IEEE P802.15 Wireless Personal Area Networks

Project	IEEE P802.15 Working Group for Wireless Personal Area Networks (WPANs)									
Title	LB97 resolutions - Kivinen									
Date Submitted	11 July, 2014									
Source	Tero Kivinen Voice: +358 20 500 7800 INSIDE Secure Fax: +358 20 500 7801 Eerikinkatu 28 E-mail: kivinen@iki.fi FI-00180 Helsinki Finland									
Re:	LB97 resolutions									
Abstract	LB 97 resolutions to CIDs 1028, 1150, 1026, 1145, 1146, 1148, 1147, 1153, 1101, 1151, 1105, 1104, 1154, R41 and R42									
Purpose	LB97 resolutions									
Notice	This document has been prepared to assist the IEEE P802.15. It is offered as a basis for discussion and is not binding on the contributing individual(s) or organization(s). The material in this document is subject to change in form and content after further study. The contributor(s) reserve(s) the right to add, amend or withdraw material contained herein.									
Release	The contributor acknowledges and accepts that this contribution becomes the property of IEEE and may be made publicly available by P802.15.

New version of the Outbound state machine:

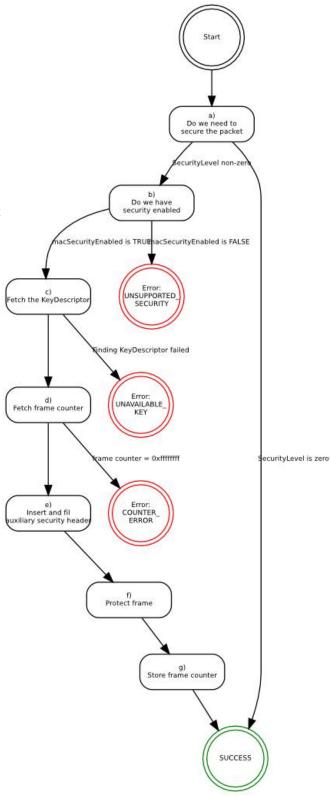
Robert	Verizon	313	9.2	16	Still need state machines for security flow	Provide state machine figures
Moskowitz

Tero Kivinen	INSIDE Secure	313	9.2.1	l	Swap steps c) and b). There is no point of checking length of the data expansion length if we are not protecting the frame. See CID 565.	Swap steps c) and b).	
--------------	------------------	-----	-------	---	--	-----------------------	--

Work In Progress, Outbound state machine done, see CID 1150 for it.
